V2500-A1/A5 SERIES PROPULSION SYSTEM SERVICE BULLETIN

This document transmits the Initial Issue of Service Bulletin V2500-ENG-73-0202.

ENGINE – FUEL AND CONTROL – P4.9 TUBE ASSEMBLIES, PRESSURE CONTROL AND BOX AND CABLE,
TC – REPLACE THE P4.9 TUBE ASSEMBLIES TO PREVENT FRACTURES AND REPOSITION THE EXHAUST
GAS TEMPERATURE (EGT) CABLE TO PREVENT CHAFING

REPLACEMENT OF EGT HARNESS BRACKETS AND EGT HARNESS CLAMPING AND ROUTING
FIGURE 1, SHEET 1

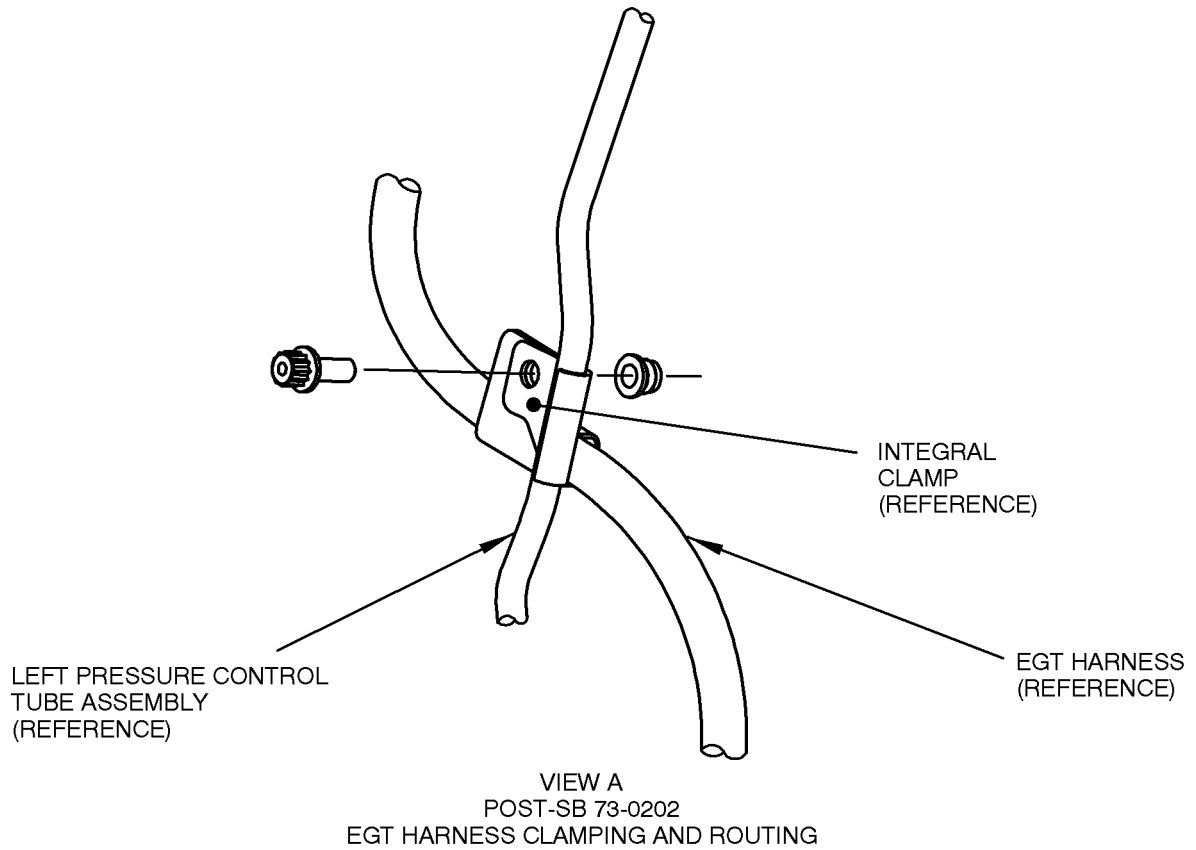
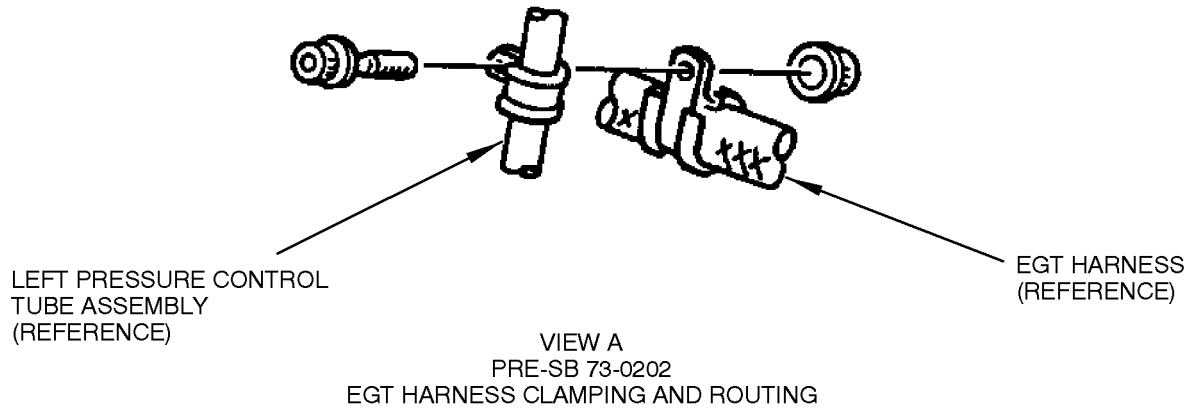
- (3) Remove the parts shown in Figure 1, Sheet 1 as specified in Reference 12, Aircraft Maintenance Manual, Chapter/Section 77-21-43, Removal of the EGT Harness and Junction Box.

- (a) Replace eight Loop Clamp Brackets, P/N 2A1629 with P/N 2A4044. During installation, tighten the fasteners that attach the brackets to 85.0 – 95.0 lbf·in (9,604 – 10,734 Nm).

- (b) Replace four Loop Clamp Bracket Assemblies, P/N 2A1854-01 with P/N 2A4042-01. During installation, tighten the fasteners that attach the bracket assemblies to 85.0 – 105.0 lbf·in (9,604 – 11,863 Nm).

- (c) Replace Loop Clamp Bracket Assembly, P/N 2A1763-01 with P/N 2A4041-01. During installation, tighten the fasteners that attach the bracket assembly to 85.0 – 105.0 lbf·in (9,604 – 11,863 Nm).

- (d) Discard two Clamps, P/N 277398 or two Cushion Loop Clamps, P/N ST1428-02.

REPLACEMENT OF EGT HARNESS BRACKETS AND EGT HARNESS CLAMPING AND ROUTING
FIGURE 1, SHEET 2

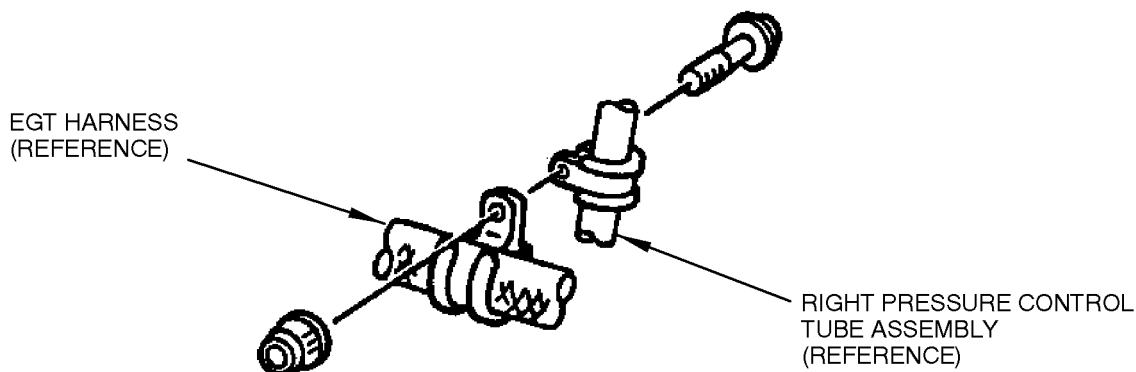
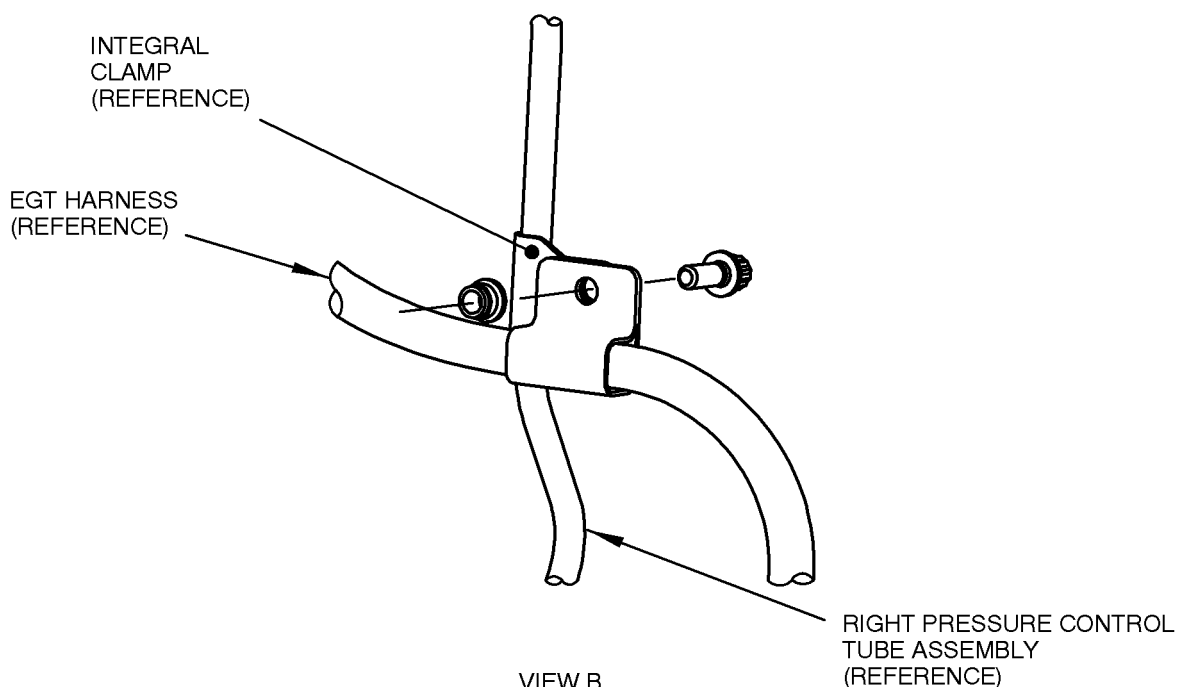
NOTE: This Service Bulletin introduces new left and right pressure control tube assemblies. The new tube assemblies include integral clamps. The integral clamps perform the same function as the clamps removed by this step. See Figure 1, Sheets 2 and 3 for the location of the integral clamps.

- (11) Install the new tubes and brackets as specified in Reference 12, Aircraft Maintenance Manual, Chapter/Section 73-22-51, Installation of the P4.9 Sensor and Manifold. See Figure 1, Sheets 2 and 3 for EGT harness clamping and routing.

LOCATION OF THE LOOP CLAMP BRACKET
FIGURE 2, SHEET 2

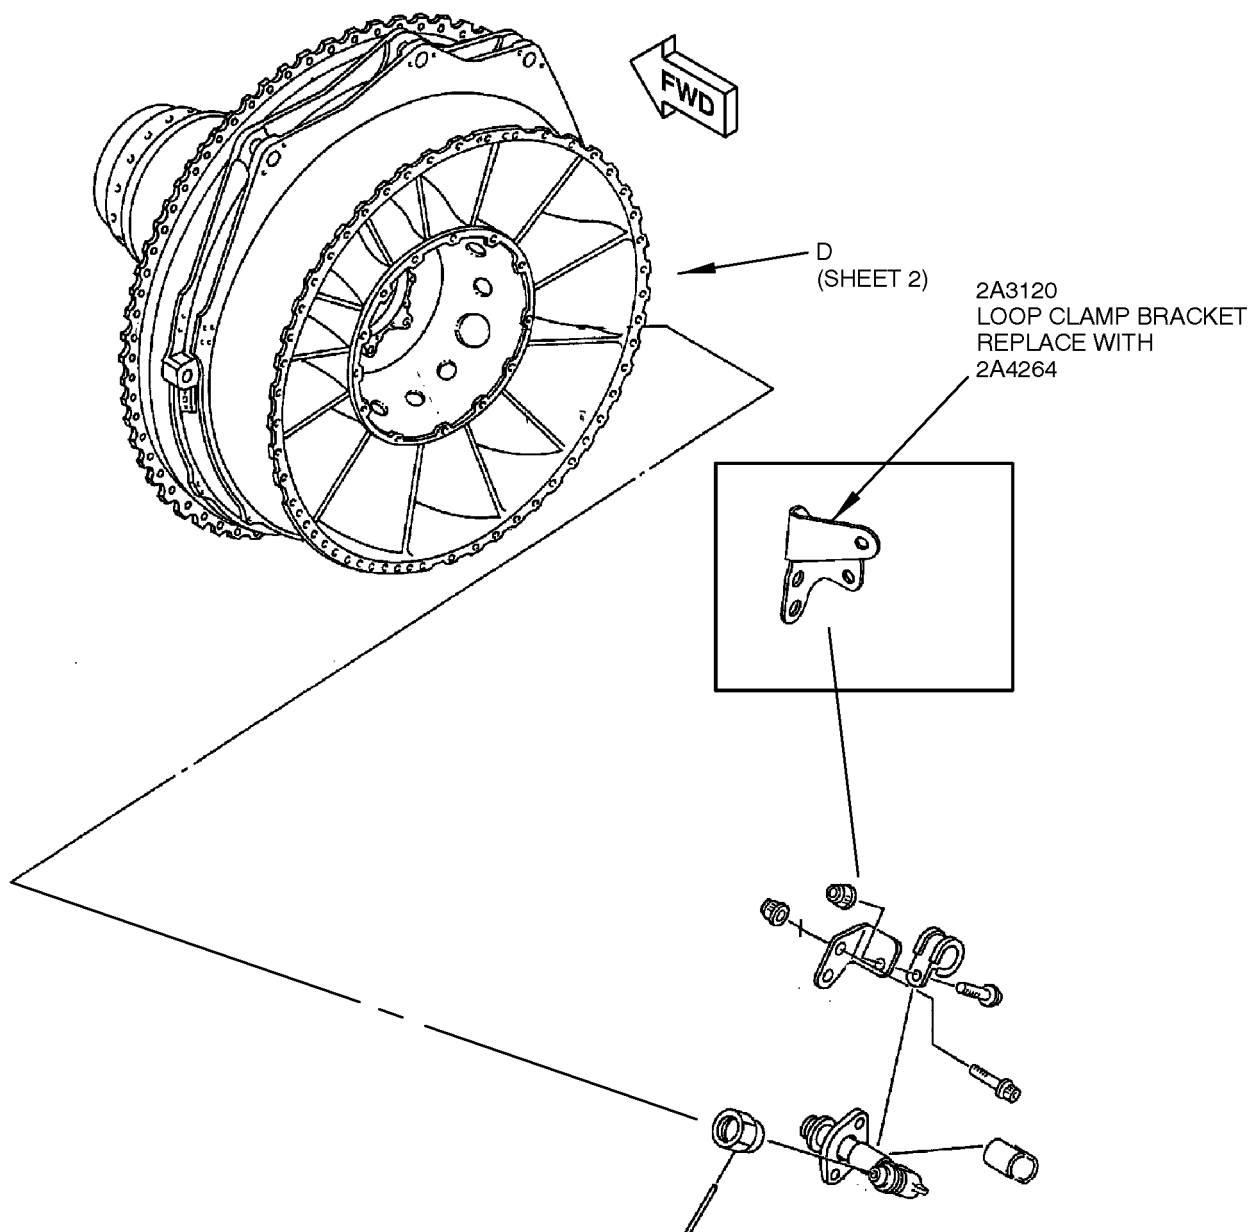
- (4) Install the new brackets as specified in Reference 12, Aircraft Maintenance Manual, Chapter/Section 77-21-43, Installation of the EGT Harness and Junction Box.
- (5) Remove and discard Loop Clamp Bracket, P/N 2A3123. See Figure 2, Sheet 2 for the location of the bracket.

- (14) Install a new Loop Clamp Bracket, P/N 2A4080 where P/N 2A3123 was previously installed. Tighten the fasteners that attach the bracket to 85.0 - 105.0 lbfin (9,604 - 11,863 Nm). See Figure 2, Sheet 2 for the location of the bracket.

LOCATION OF THE LOOP CLAMP BRACKET
FIGURE 3, SHEET 2

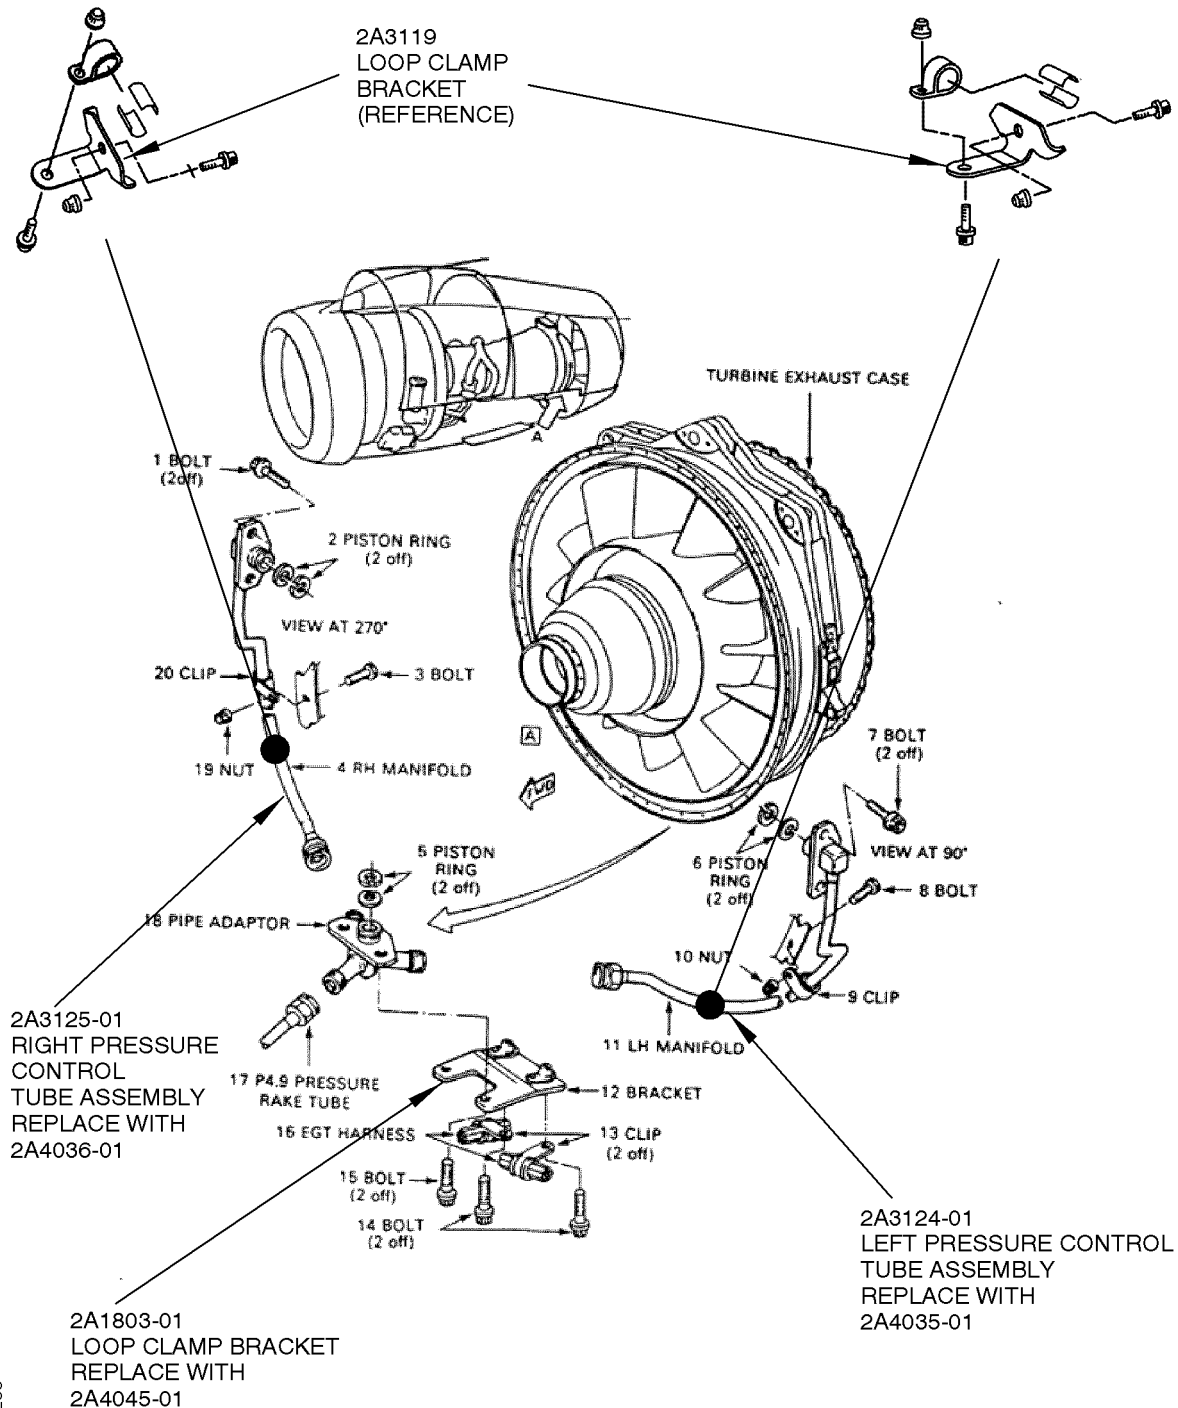
- (6) Remove and discard Loop Clamp Bracket, P/N 2A3120. See Figure 3, Sheet 2 for the location of the bracket.
- (7) Loosen the fasteners that attach the loop clamps to the two Loop Clamp Brackets, P/N 2A3119. See Figure 4.

- (15) Install a new Loop Clamp Bracket, P/N 2A4264 where P/N 2A3120 was previously installed. Tighten the fasteners that attach the bracket to 85.0 - 105.0 lbfin (9,604 - 11,863 Nm). See Figure 3, Sheet 2 for the location of the bracket.

REPLACEMENT OF P4.9 BRACKET AND TUBE ASSEMBLIES
FIGURE 4

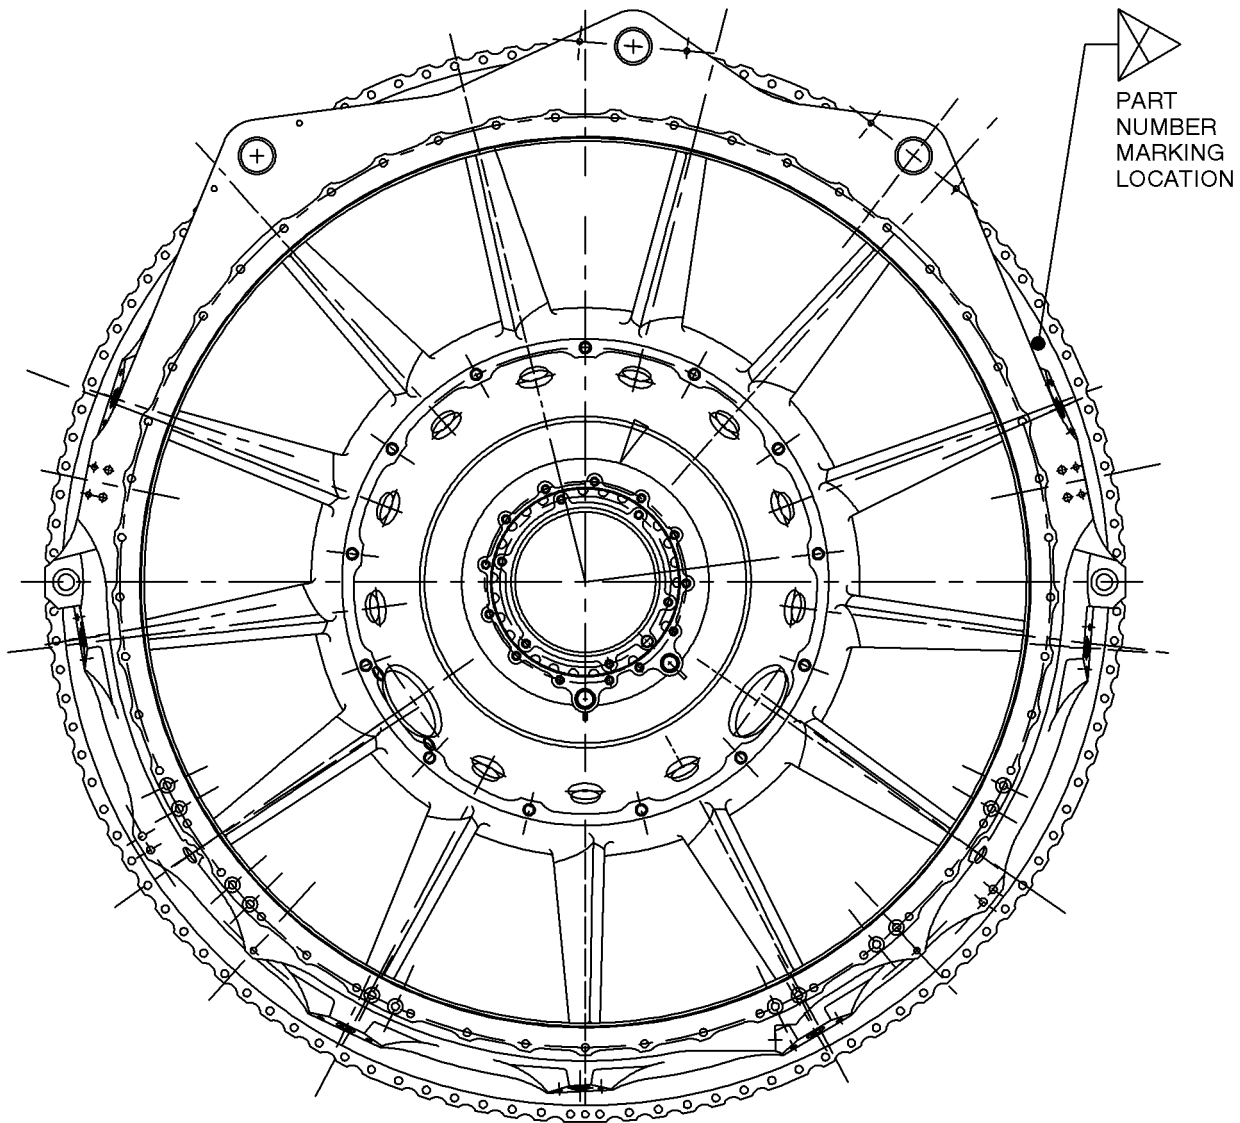
- (8) Remove the parts shown in Figure 4 as specified in Reference 12, Aircraft maintenance Manual, Chapter/Section 73-22-51, Removal of the P4.9 Sensor and Manifold.

- (a) Replace the Left Pressure Control Tube Assembly, P/N 2A3124-01 with P/N 2A4035-01.
 - (b) Replace the Right Pressure Control Tube Assembly, P/N 2A3125-01 with P/N 2A4036-01.

- (c) Replace Loop Clamp Bracket, P/N 2A1803-01 with P/N 2A4045-01. During installation, tighten the fasteners that attach the bracket to 85.9 - 105.9 lbfin (9,604 - 11,863 Nm).

- (13) Tighten the fasteners that attach the loop clamps to the two Loop Clamp Brackets, P/N 2A3119 to 36.0 - 45.0 lbfin (4,067 - 5,084 Nm). See Figure 4.

IDENTIFICATION OF THE MODIFIED TURBINE EXHAUST CASE GROUP
FIGURE 5

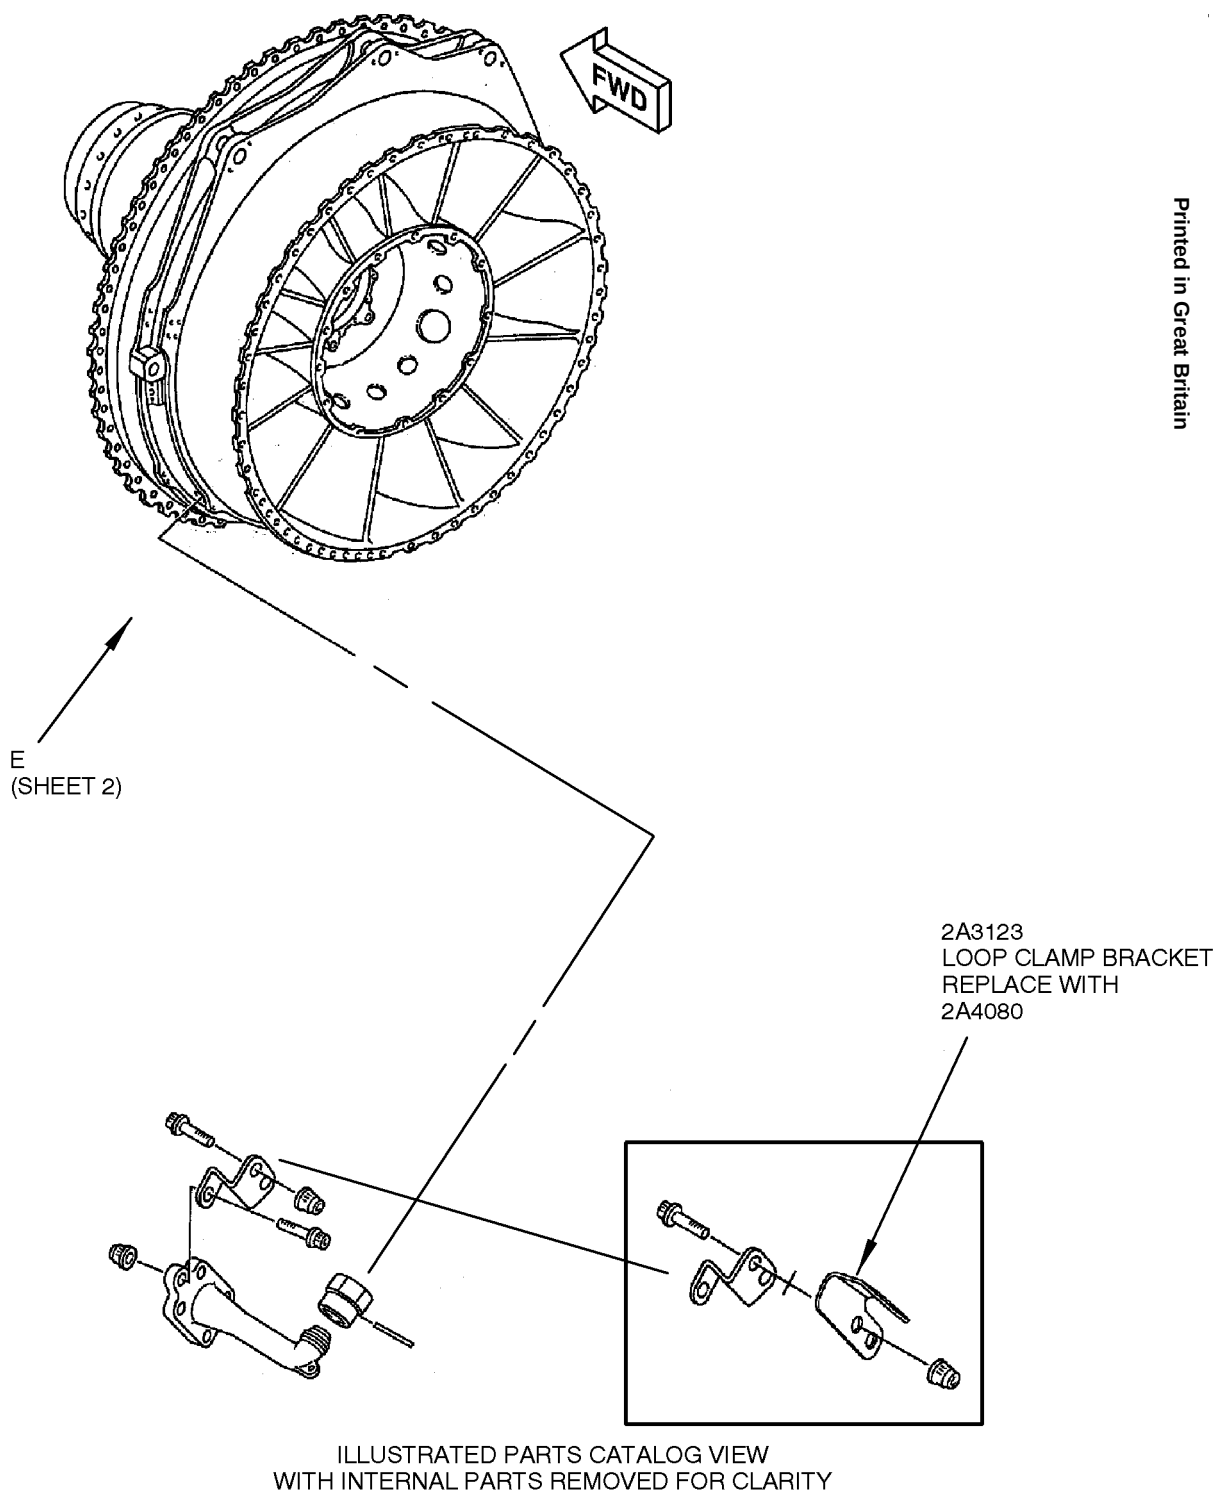
- (16) Identify the turbine exhaust case group as shown in Table 1. Mark the part number in the same location of the existing part number and maintain the same serial number. See Figure 5 for the location of the marking.

LOCATION OF THE LOOP CLAMP BRACKET
FIGURE 6, SHEET 2

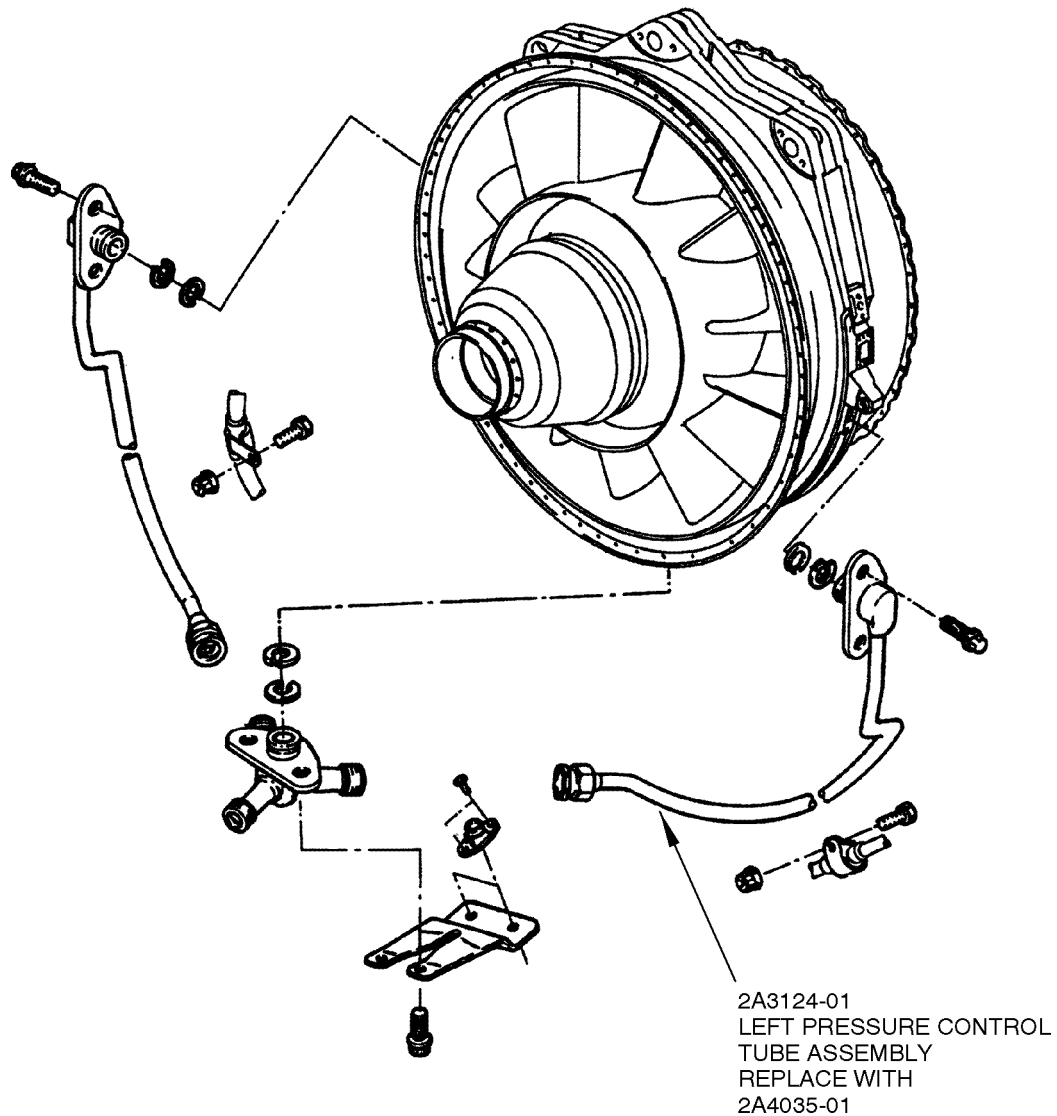
- (1) Do the following procedures on the left side of the turbine exhaust case group during engine assembly:
- (a) Replace Loop Clamp Bracket, P/N 2A3123 with P/N 2A4080. See Figure 6, Sheet 2 for the location of the bracket.
 - (b) Replace the Left Pressure Control Tube Assembly, P/N 2A3124-01 with P/N 2A4035-01. See Figure 7 for the location of the tube assembly.
